# Platform location N05a

Demarcation of the habitat type "Reef " (H1170)  
following BfN (2018)

**Client:**  
Deutsche Umwelthilfe  
Berlin

Contractor: BioConsult GmbH & Co.KG

**Fig. 3:** Environmental seabed features chart platform area N05a (from: MarineSpace 2022a).

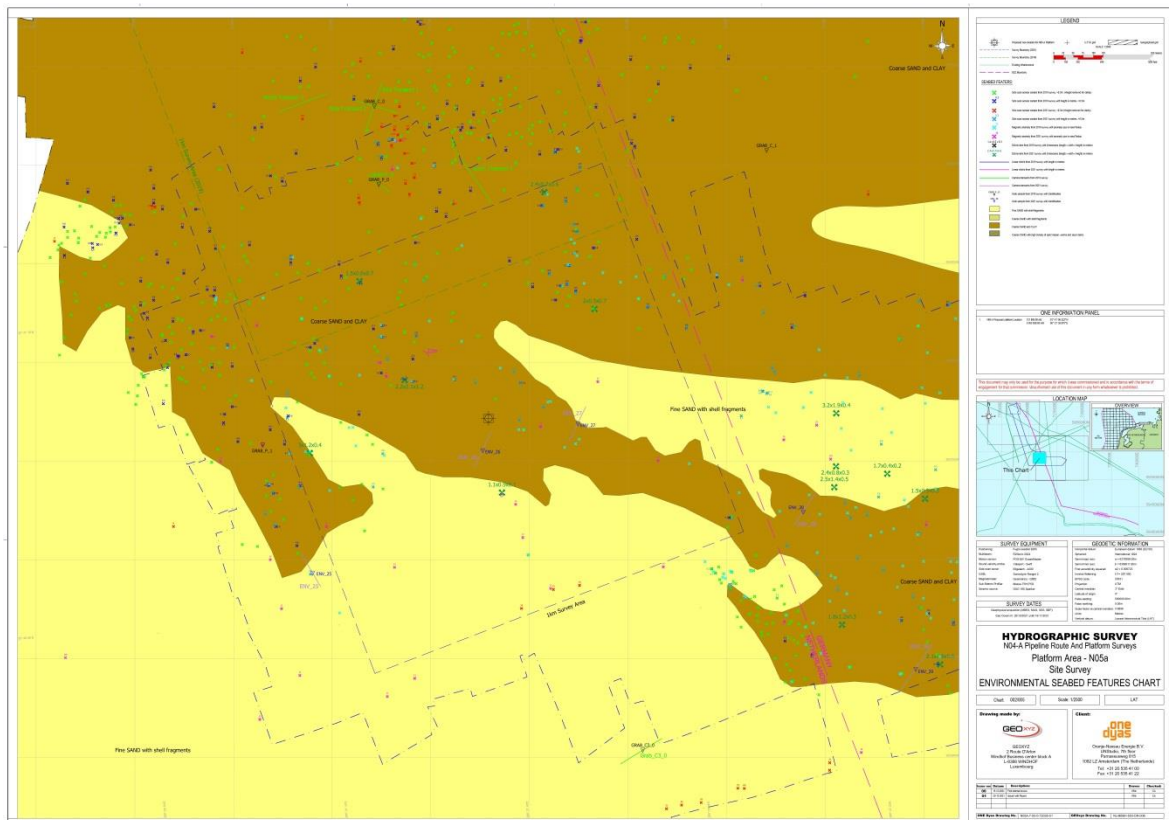
The basis for the demarcation of the reef are the data collected by GEOxyz (see MarineSpace (2022a und 2022b), each in Appendix C) for sediments and seabed features >0.3 m (see Fig. 3 and Fig. 4). In this regard, the text about the platform location (MarineSpace 2022a) and cable route (MarineSpace 2022b) states:

enced map at a scale of 1 : 5,000. 64 of the 372 "objects" >0.3-0.5 m from Fig. 3 are located within the survey area. Another 314 "objects" >0.3-0.5 m are located in the area of the cable route to OWF Riffgrund (Fig. 4).

Fig. 4: Environmental seabed features chart cable route (from: MarineSpace 2022b).

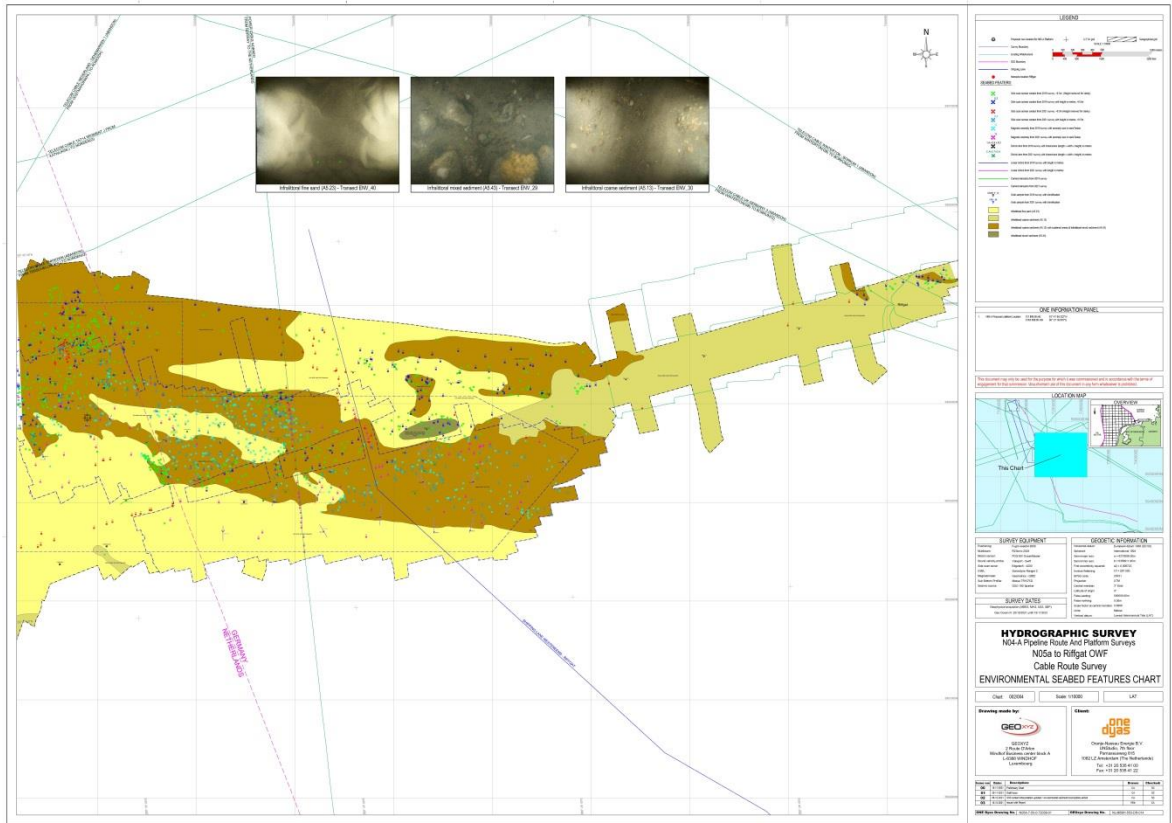
In the area of the video transect ENV\_29 lies an area that is described as "Coarse SAND with a high density of sand mason, worms and razor clams" by GeoXYZ (see Fig. 4) and according to EUNIS classified as "Infralittoral mixed sediment (A5.43)". The still image from this transect (see Fig. 6) that is included in MarineSpace (2022b, Appendix C) shows that not only gravel but also smaller stones with reef-typical fauna occur. This area lies almost entirely in the aggregation of boulders with the ID 24 from the year 2019.

Fig. 5: Reef areas following BfN (2018).

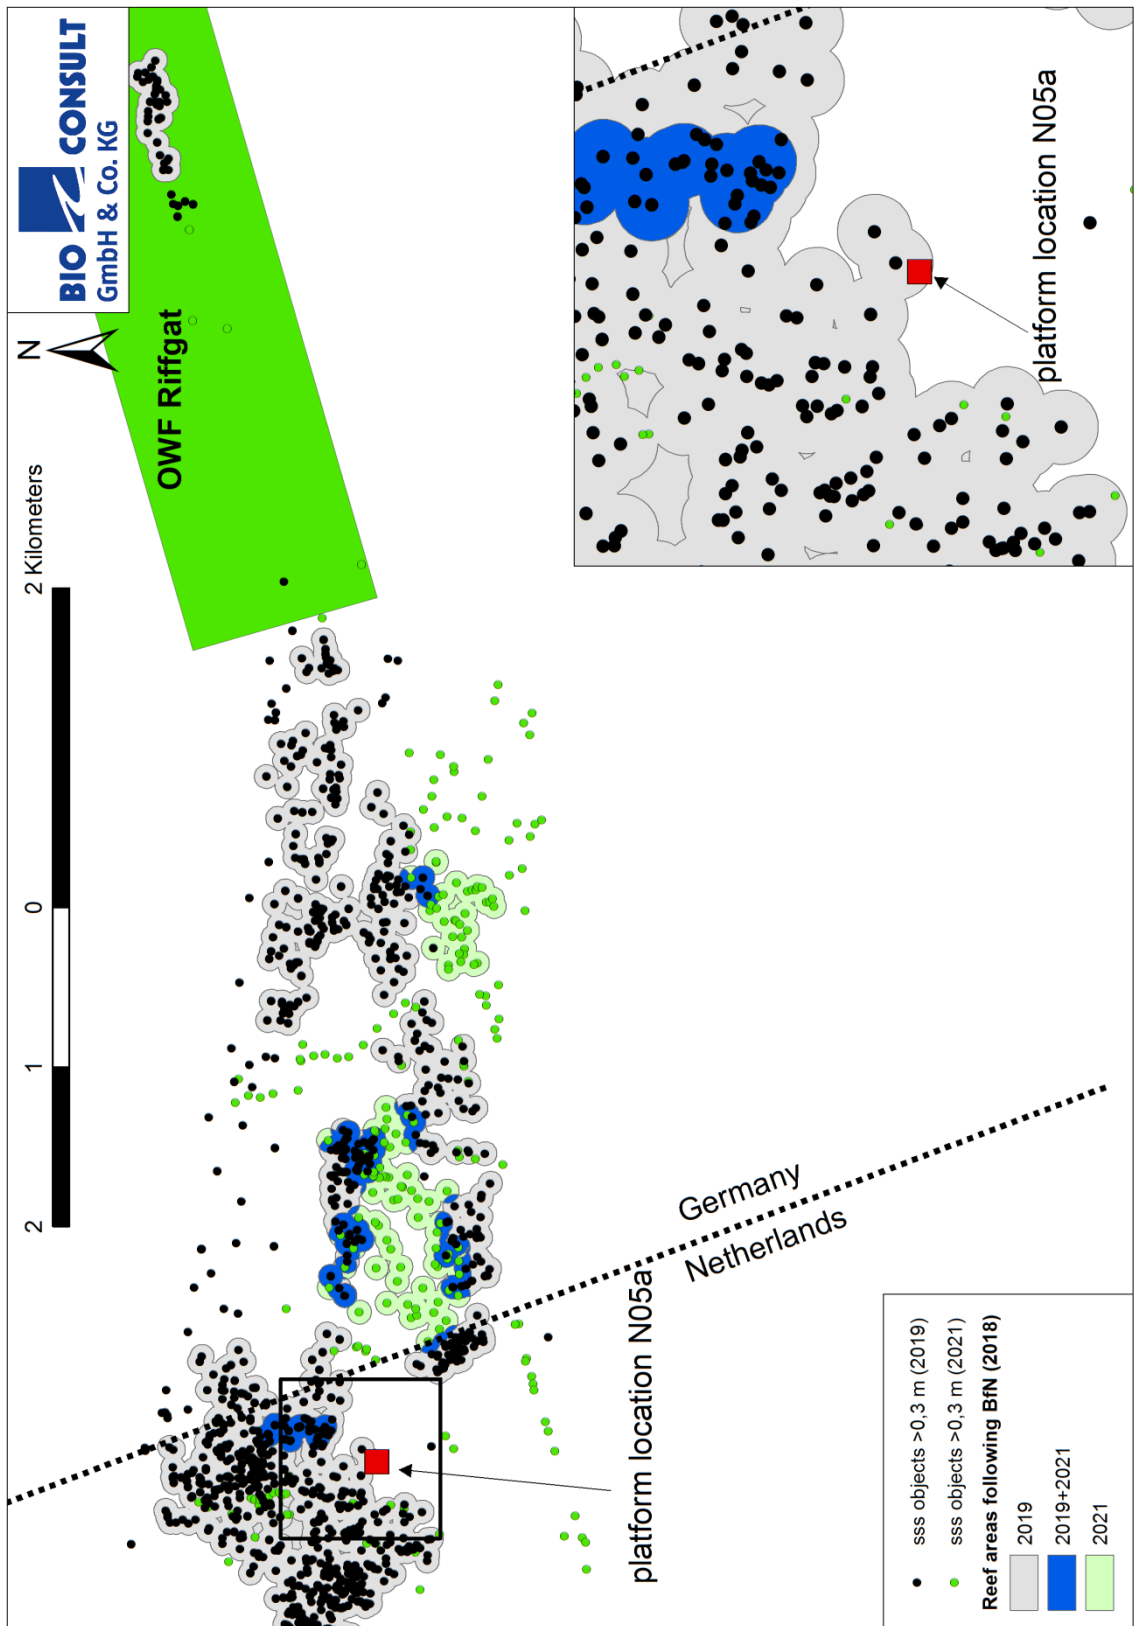
Since in all aggregations of boulders the mean distance to the nearest neighbor was  $\leq 50$  m (criterion 3), the nine aggregation from the year 2019 and the four aggregations from the year 2021 are to be classified as geogenic reefs of the type „boulder field (North Sea)“ according to the mapping guidelines of the BfN.

To illustrate the differences between the years 2019 and 2021, the reef areas resulting from the buffer zones are shown in different colors in Fig. 5. Accordingly, only small areas are classified as the reef type "boulder field" in both years. Since the distribution of boulders is similar in both years despite the lower number of boulders in the year 2021, it is likely that they are still present in the area but covered by sediment. Another reason for the differences between the years could be due to the methodology in collecting and evaluating the SSS. Based on the available documents it cannot be said if methodological differences play a role.

Fig. 7: Potential reefs "Borkumse Stenen" (from BOS et al. 2014) and platform location N05a.

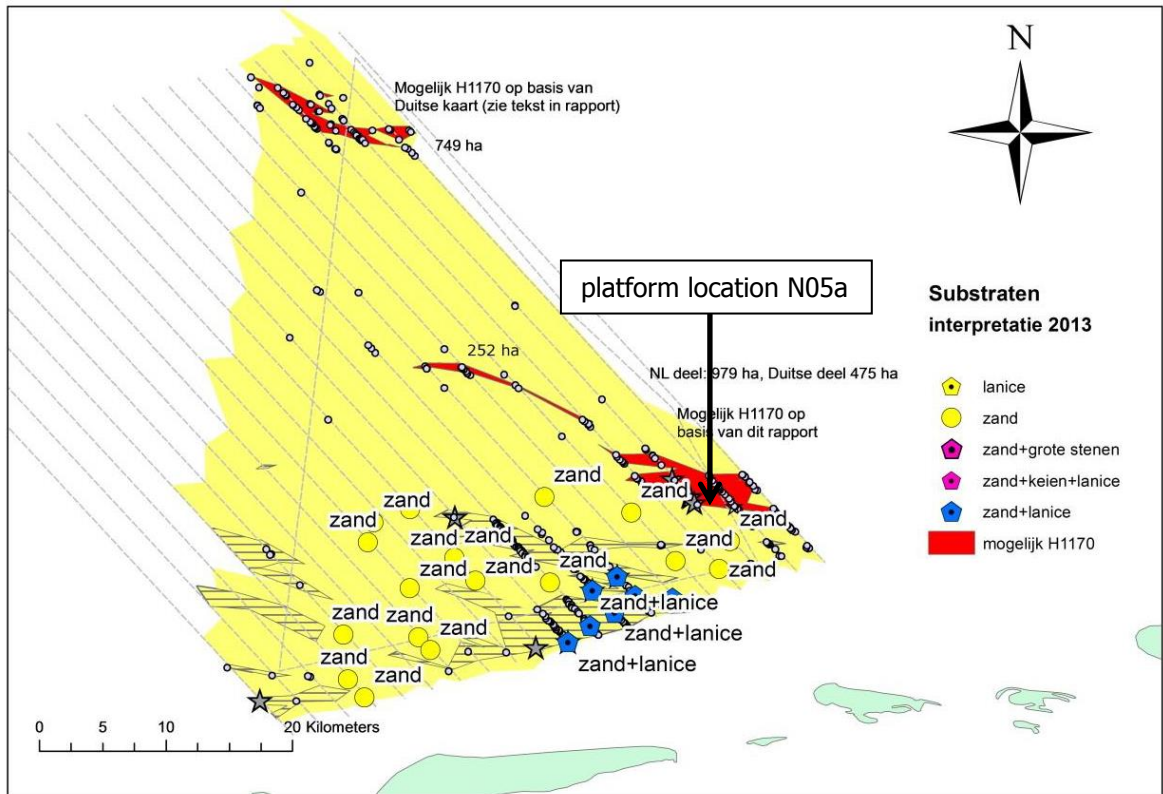
The most important summary study on the benthic habitats of the area "Borkumse Stenen", in which the platform location N05a is situated, is from BOS et al. (2014). As can be seen in Fig. 7, the platform location N05a is situated at the southern edge of an area classified potentially as a reef (H1170) by BOS et al. (2014). These results correspond to the reef demarcation according to the mapping guidelines of the BfN (see Fig. 5).
